[Docket No. FAA-2015-7527; Directorate Identifier 2015-NM-094-AD; Amendment 39-18686; AD 2016-21-05]

Airworthiness Directives; The Boeing Company Airplanes

ACTION: Final rule.

Figure 1 to paragraph (h) of this AD: Wiring Installation - Right Engine Fuel Spar Valve

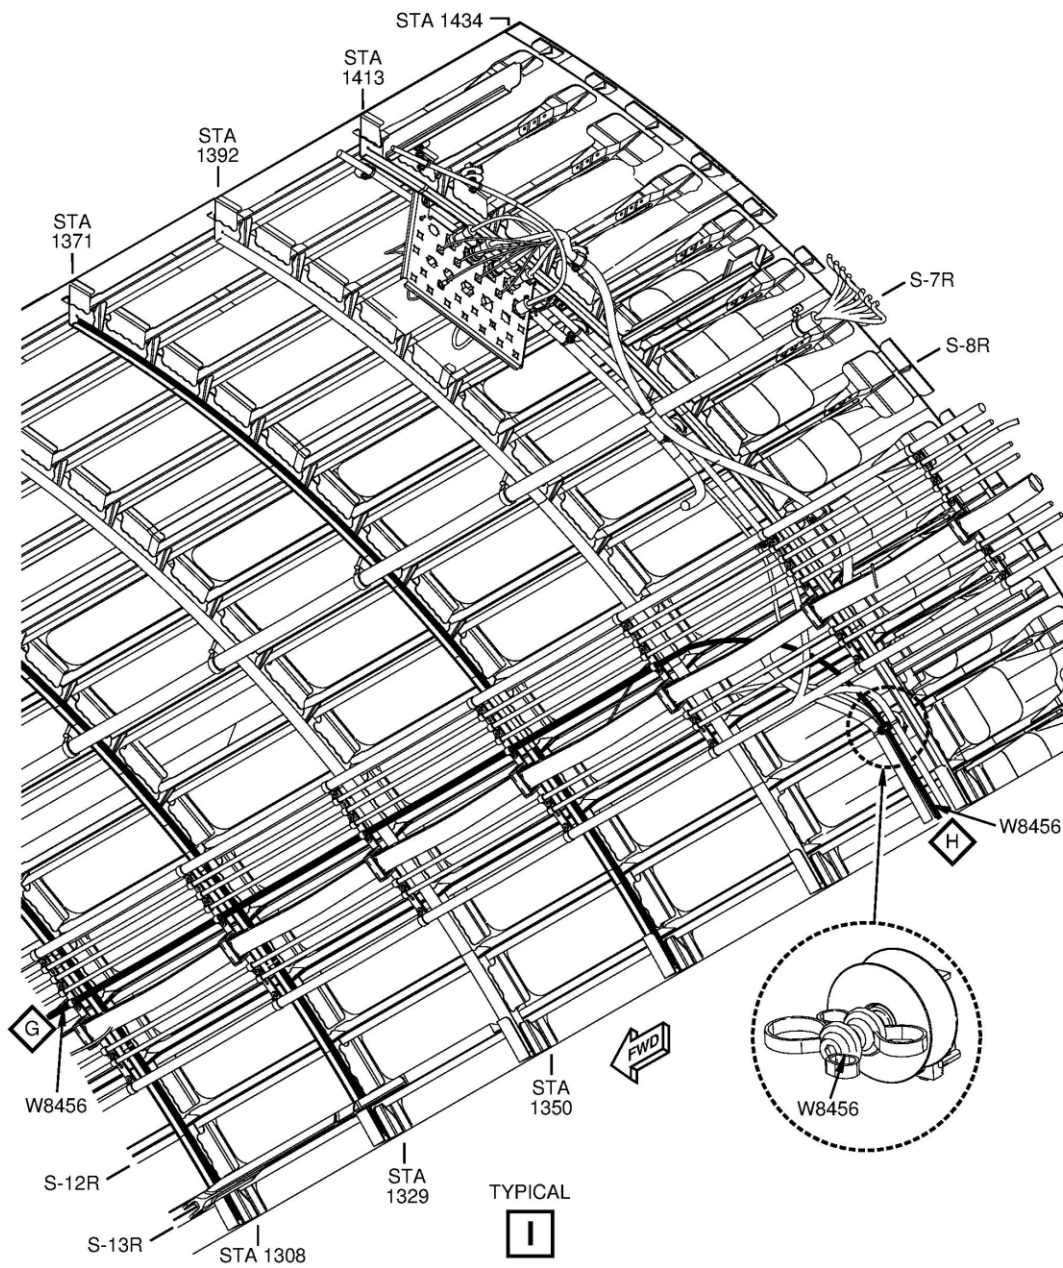
ANA requested that we include Boeing Service Bulletin Information Notice 777-28-0061, IN 03, dated November 16, 2015, to this AD to allow the operators to complete the proposed requirements of the NPRM.

an appropriate source of service information in this AD because it is not an FAA-approved document. However, we acknowledge that for certain airplanes, Figure 22, Sheet 9, of Boeing Special Attention Service Bulletin 777-28-0061, Revision 2, dated May 4, 2015, includes an editorial error, which shows incorrect wire routing. Boeing Service Bulletin Information Notice 777-28-0061, IN 03, dated November 16, 2015, allows for a modification of Group 2 airplanes that meets the requirements of the AD without an additional burden to operators. We have included a corrected figure in paragraph (h) of this AD to address this issue.

(1) Where Boeing Special Attention Service Bulletin 777-28-0061, Revision 2, dated May 4, 2015, specifies to use Figure 22, Sheet 9, for the wiring installation of the right engine fuel spar valve, this AD requires using figure 1 to paragraph (h) of this AD.
